**ANALYSIS OF COASTAL BLUFF MORNING-GLORY
(*CALYSTEGLIA PURPURATA* SSP. *SAXICOLA*)
POPULATION**

SECOND ESHA
REPORT - ALTERNATIVE
ANALYSIS

EXHIBIT NO. 14
APPEAL NO. A-1-MEN-05-037 (PIETY/PANELLI) JUNE 2004 ANALYSIS OF COASTAL BLUFF MORNING- GLORY HABITAT

BACE Geotechnical a division of Bruning Associates, Inc. (707) 838-0780	Job No.: 11798.1 Appr.: EEO Date: 8/29/03	SITE PLAN PLANNED PIETY RESIDENCE 47021 Pirates Drive Guatala, California	PLATE 3
	Reference: Topographic Map, May 2002, prepared by E and J Professional Land Surveying

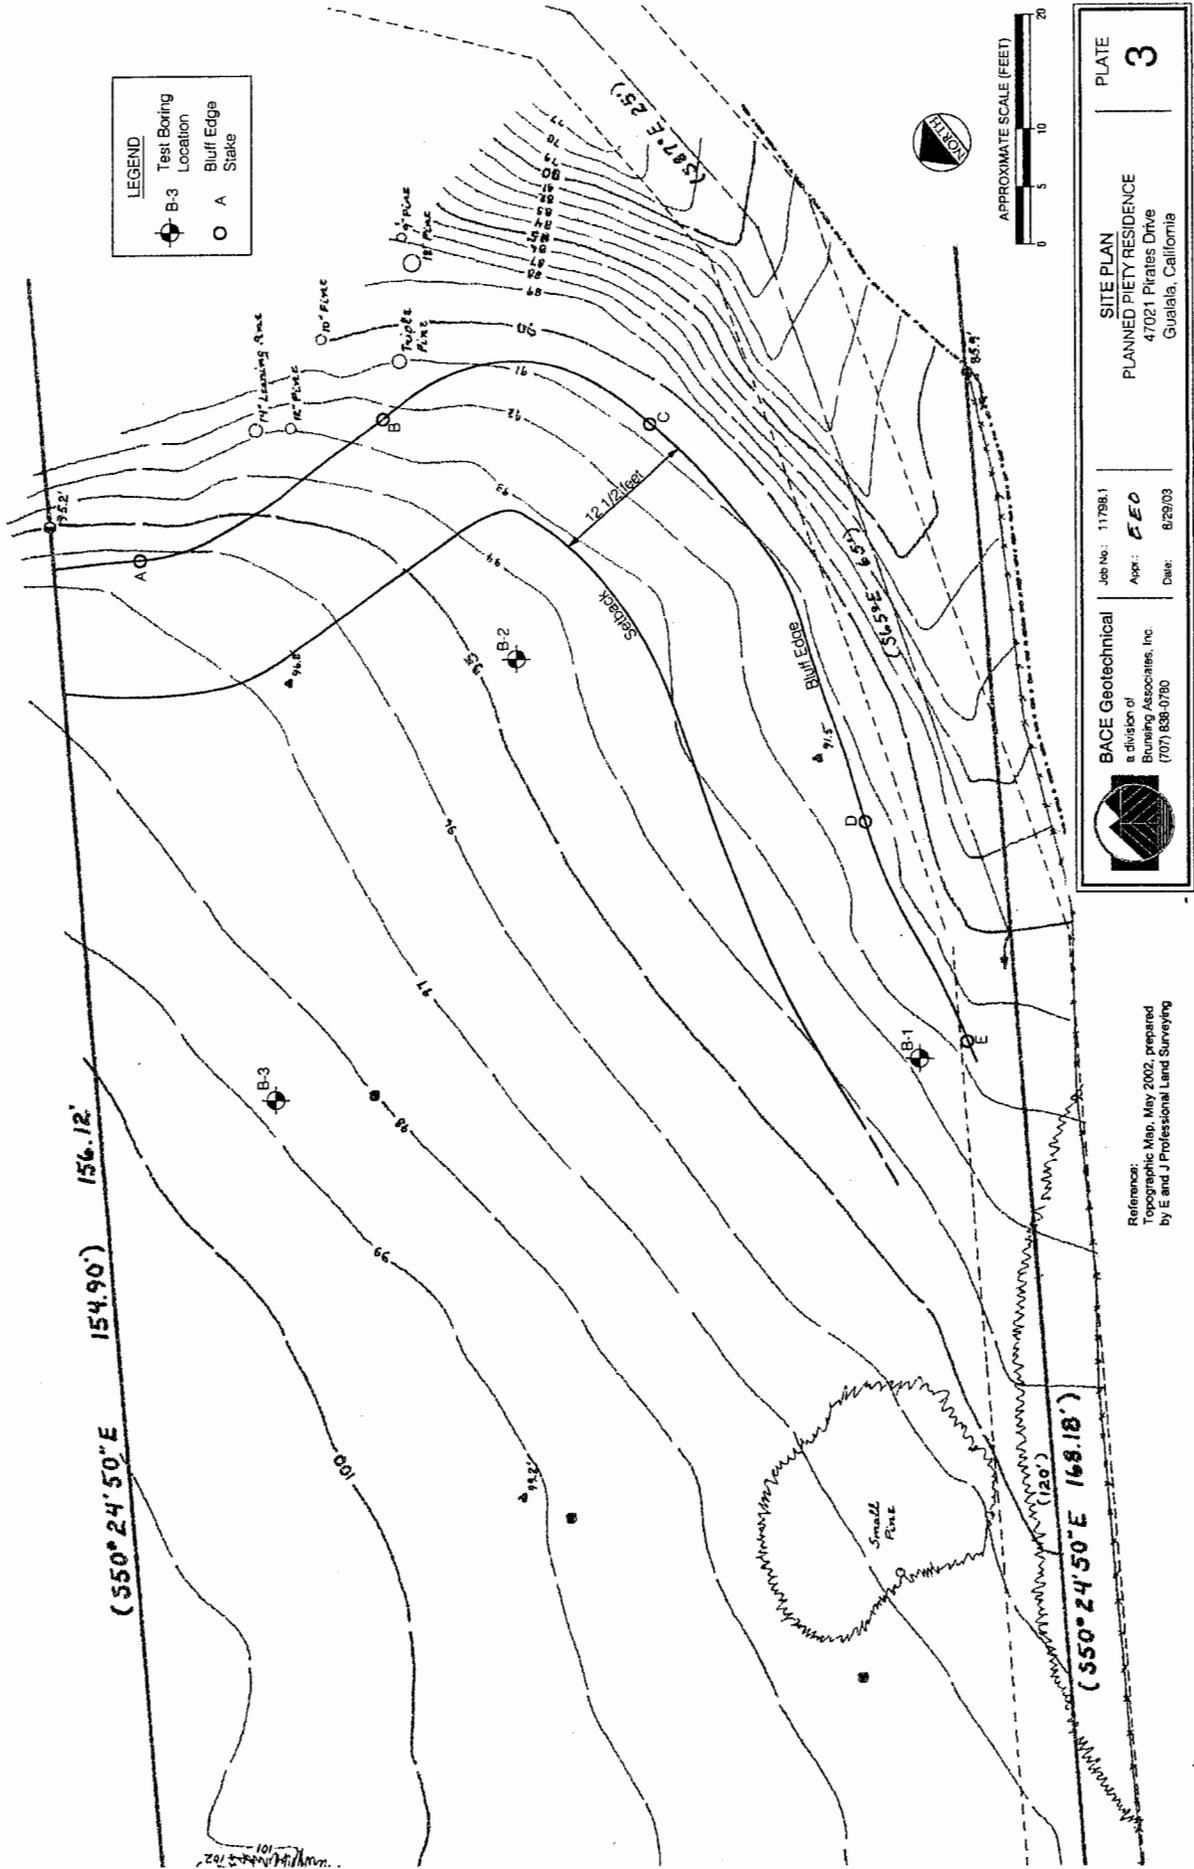
The CCC staff report states that BACE never "addressed the 'severe erosion' under the trees that is shown as sloping on his topographical map". The topographic map that BACE used for the Site Plan, Plate 3 of our 2003 report was, as referenced, prepared by Edward R. Way; not BACE. The "severe erosion" is on the upper portion of the near-vertical cut bank for the beach trail on the Piety property. The weak soils on the upper portion of the cut have eroded back, as expected, except where the masses of shallow tree roots are holding the surficial soils in place. Where this has happened, the weak soils beneath the root mass have eroded away, leaving an overhang of approximately 12 to 18 inches. The rocks exposed in the lower portion of the trail cut have remained intact. This erosion within the upper soils was not mentioned in either our original report or our recent response letter since this is a minor, localized feature of little or no significance.
